**72.48 Applicability Analysis for Changes, Tests, Experiments****Description of Activity:**

GE-MO License SNM-2500, Section 4.0, Paragraph 4.8.1 specifies basin water chemistry values for pH (4.5 to 9.0), NaNO_3 (<200 ppm), and Cl (<10 ppm). This 72.48 provides evaluation of a proposed change in water conductivity value to 1.35 (equivalent 5.5 to 8.0 pH) and eliminate NaNO_3 and Cl measurements.

TO: Morris Operation Safety Committee
FROM: Christopher A. Roche
DATE: July 28, 2004
SUBJECT: **Justification for Updating Basin Chemistry Technical Specifications**

This report will propose changes to the Technical Specifications in section 4.8.1 of SNM-2500 and provide justification for the proposed parameters.

**pH-Conductivity Permissible Domain
for NaCl System at 25 degC**

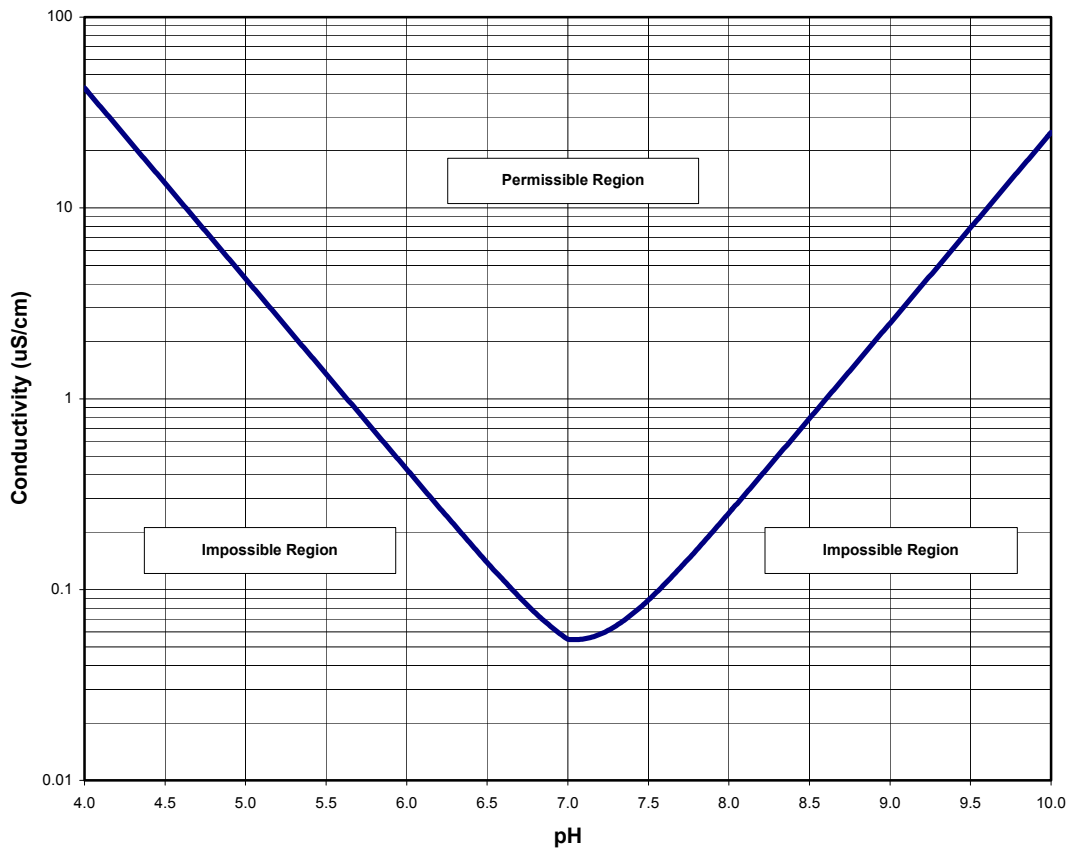
The following graph shows the permissible pH range for a given conductivity. A conductivity limit of 1.35 $\mu\text{mho/cm}$ would maintain the pH of the basin water between 5.50 and 8.73. This is more restrictive than the current specification of 4.50 to 9.00. The average conductivity of the basin water since March 1976 is 1.07 $\mu\text{mho/cm}$. This conductivity has a pH range of 5.60 to 8.83.
